DIMENSION ARE MILLIMETERS	SCALE	10 / 1	REV	G	UNIT	MM	JYE BAO CO., LTD. TAIPEI TAIWAN	
UNLESS OTHERWISE SPECIFIED TOLERANCES 0~20 = ±0.03 20~50 = ±0.05 50~ = ±0.10	APPROVE					DATE		
	CHECKED					DATE		TITLE
	DRAWN					DATE		DRAWING NO.
							FERRULE	
							SMA3100D-0316-7

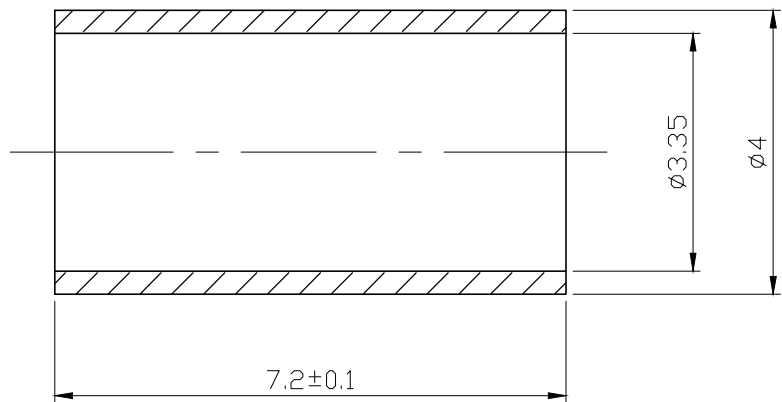
REVISION			
REV.	DESCRIPTON	DATE	APPROVED
E	增加熱處理,材質改COPPER 總長度放寬公差為±0.1	2008/10/09	
F	公差修正 $\phi 4^{+0.05}_{-0} \Rightarrow \phi 4^{+0}_{-0.02}$	2008/12/24	
G	尺寸修改 $\phi 3.4 \Rightarrow \phi 3.35$	2010/09/27
